Consider approving Change Order #5 from Workman for Southwest Regional Park in the amount of \$7,382.73.

RE: Williamson County Regional Park

**Proposed Change Order #5**

**TITLE:** Temporary Fence - *REVISED*  
**PROJECT:** Williamson County Regional Park  
**TO:** Land Strategies Inc.  
1010 Land Creek Cove  
Suite 100  
Austin, TX 78746  
**ATTN:** Paul Linehan

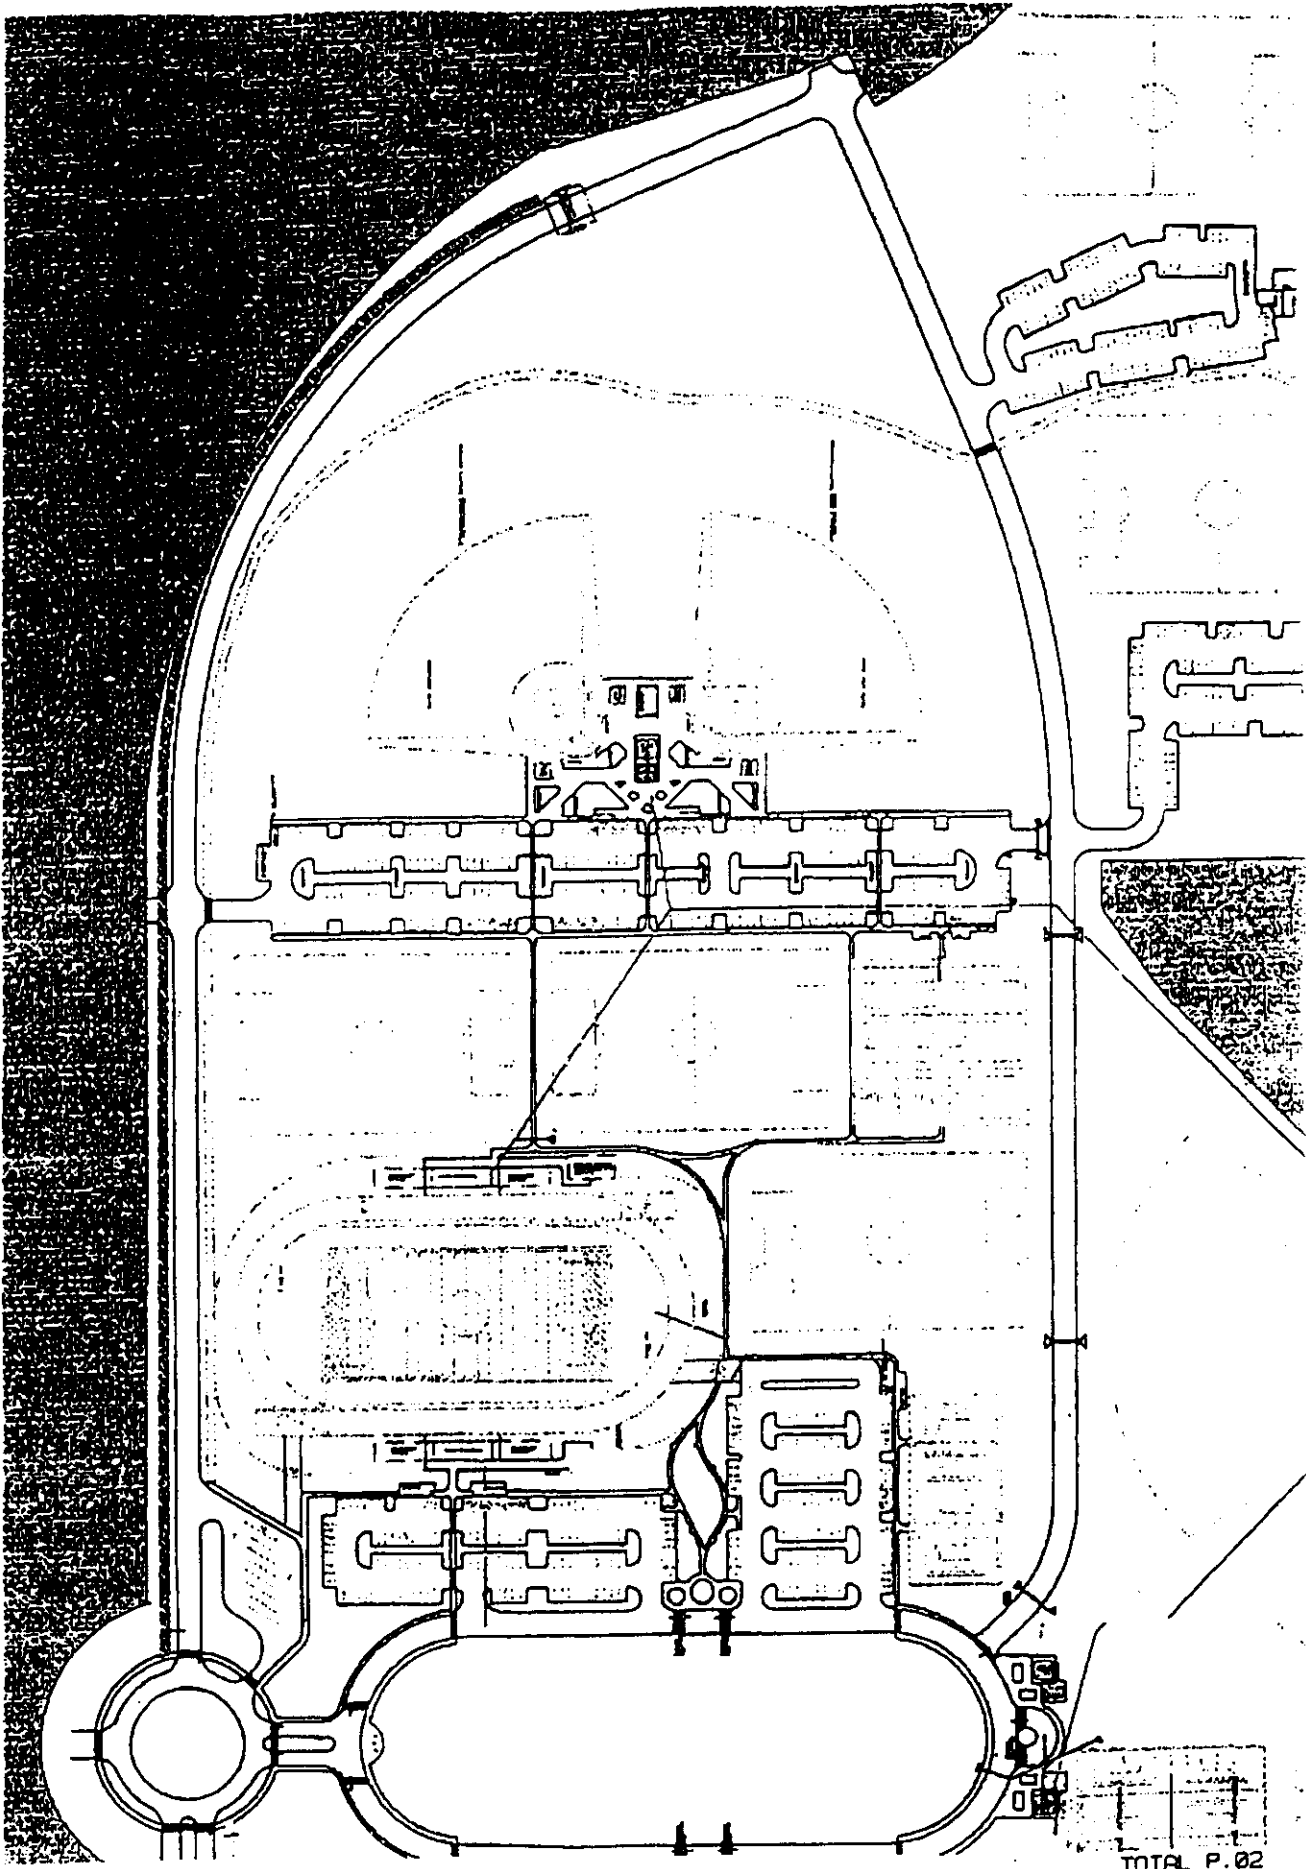
This change incorporates the cost to install chain link temporary fencing along Roadway A as shown on fax transmission received from Land Strategies at the Williamson County Regional Park project. Please see attached for reference.

Re: Bus Parking Lot Dimensional Control  
Williamson County Regional Park

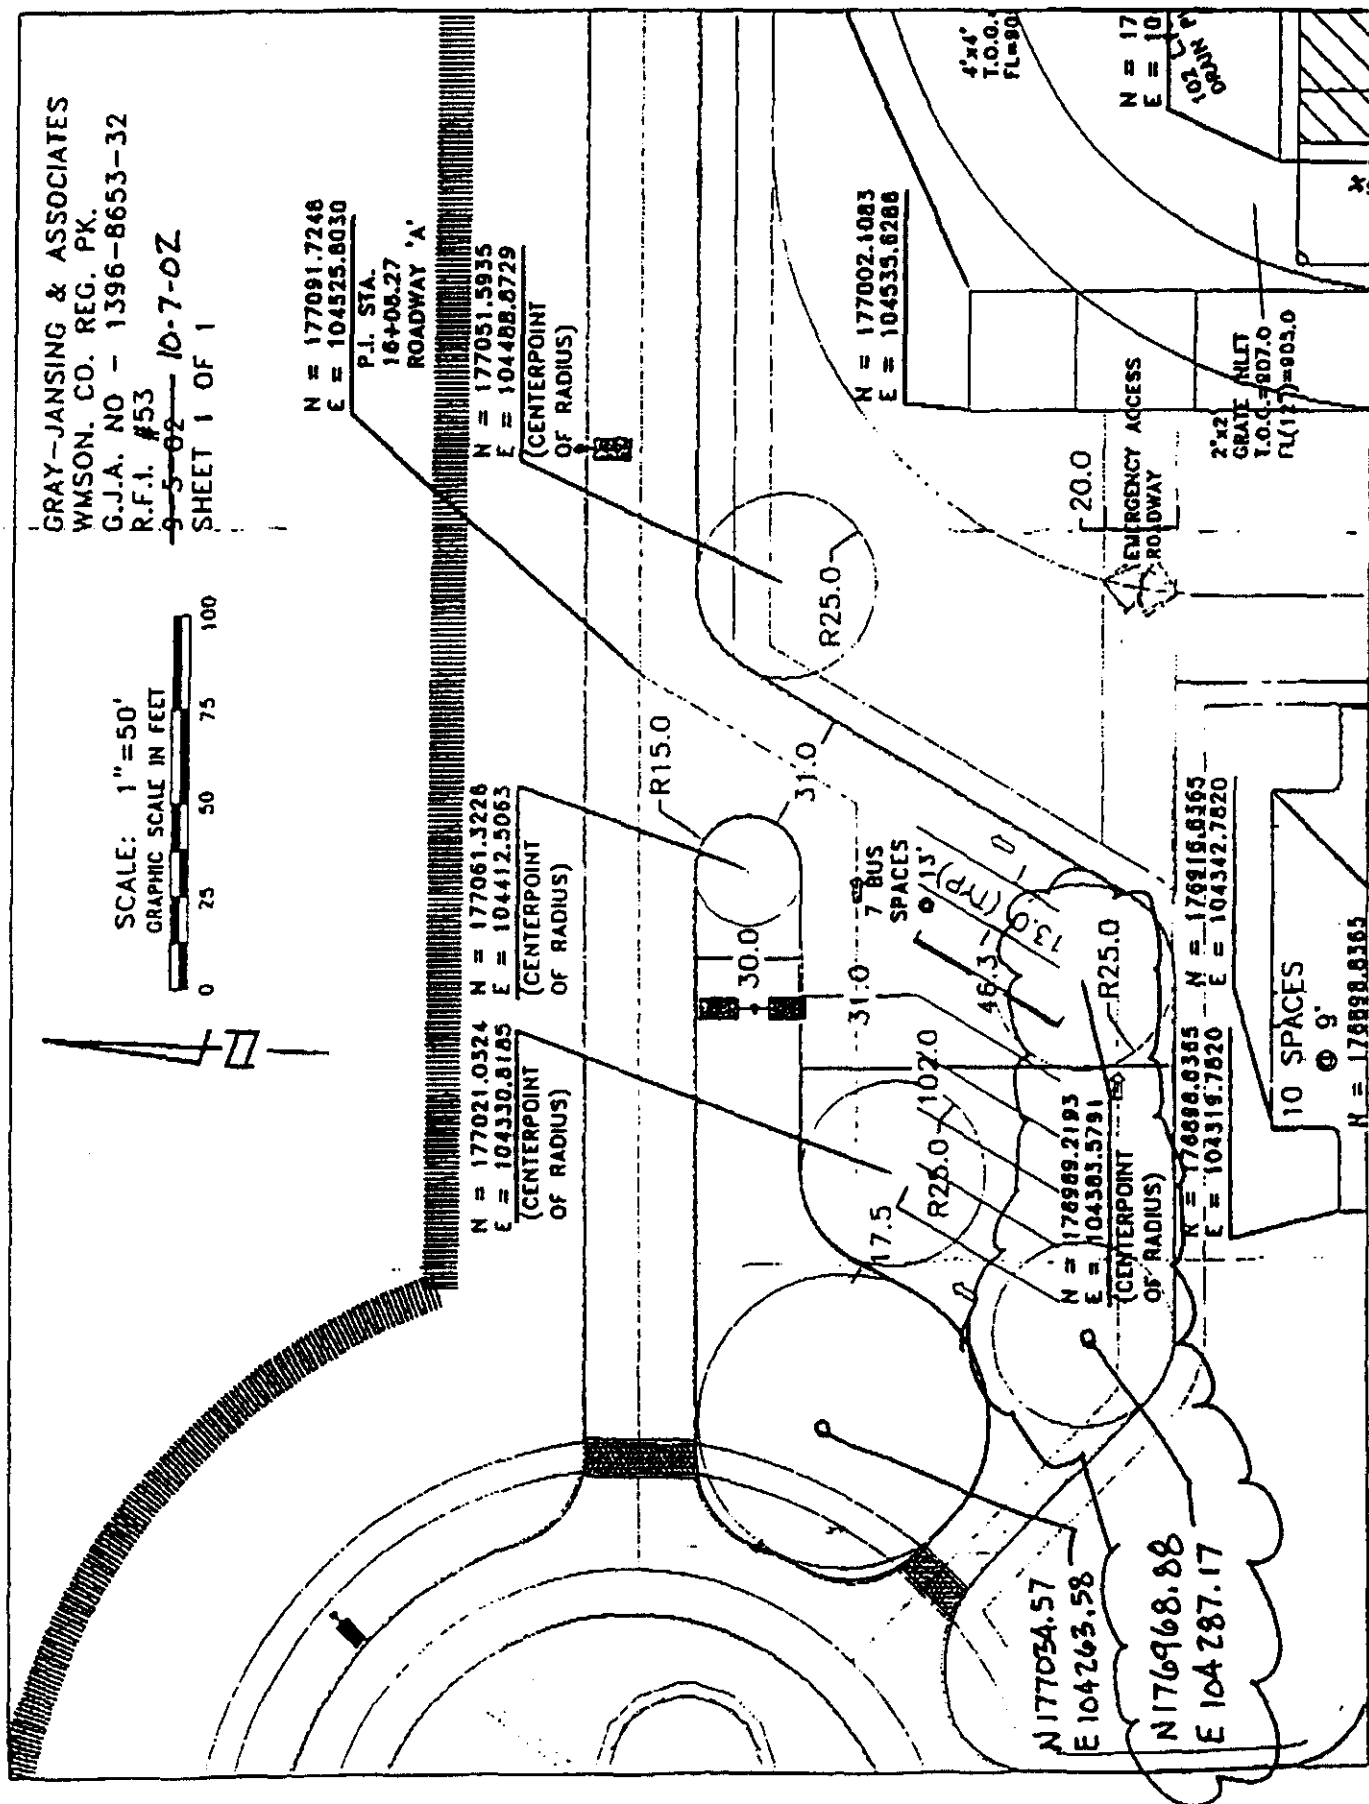
We have checked the coordinates of the center points for the two radius points as requested. The attached figure provides those coordinates. Please note that the western point did not change from the original coordinates provided on Sheet C-37 since this area of the bus parking lot has not been modified. The eastern point was the same coordinate as that provided in RFI No. 53 response dated September 4, 2002 which provided the revised bus parking lot layout.

1 BUILDING C & E SECTION

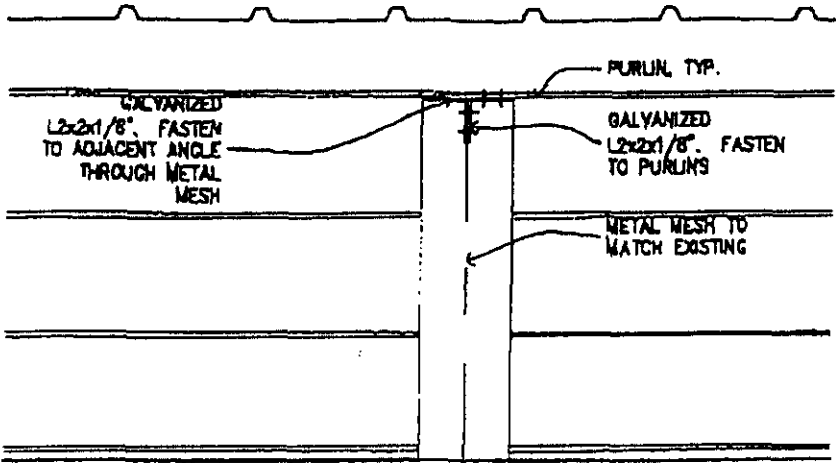
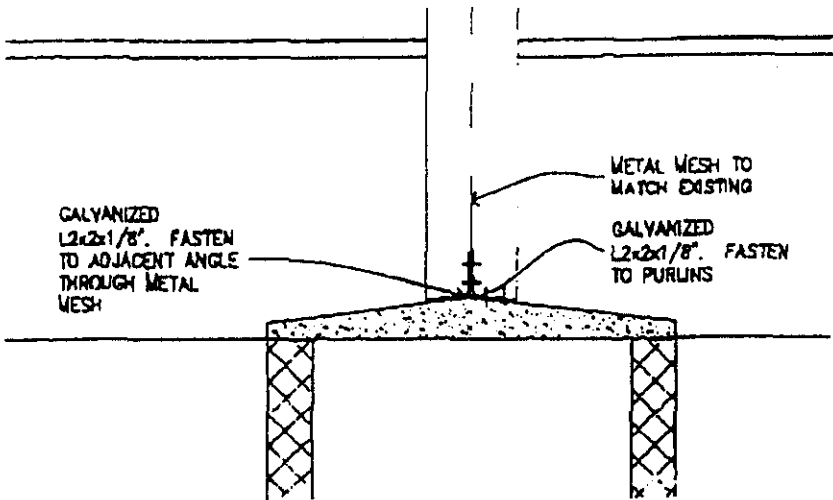
This change incorporates fabricating and installing metal mesh partitions in Building C and E at the Williamson County Regional Park project. This price includes: shop drawings for approval; shop fabrication; all labor, material, equipment, and incidentals required to install partitions. Mesh partitions shall be installed in three sections since this material cannot be fabricated in the size required for one piece. Mesh partitions to be installed as shown on Moman Architects RFP dated 10/24/02. Please see attached.

Provide the costs to ADD the wire mesh between the Men & Women in Bldgs. C & E.

- a) Partition shall be made in three (3) framed 8'-0 sections with a vertical plate in the center to splice the 4'-0 mesh panels.
- b) Frame shall be double angle 2 X 2 X 1/8 and vertical plate shall also be on both sides to hide the required splice.
- c) Bottom cord shall be bent plate to match sloped concrete with plates added to anchor frame to concrete.
- d) Field measurements are excluded.
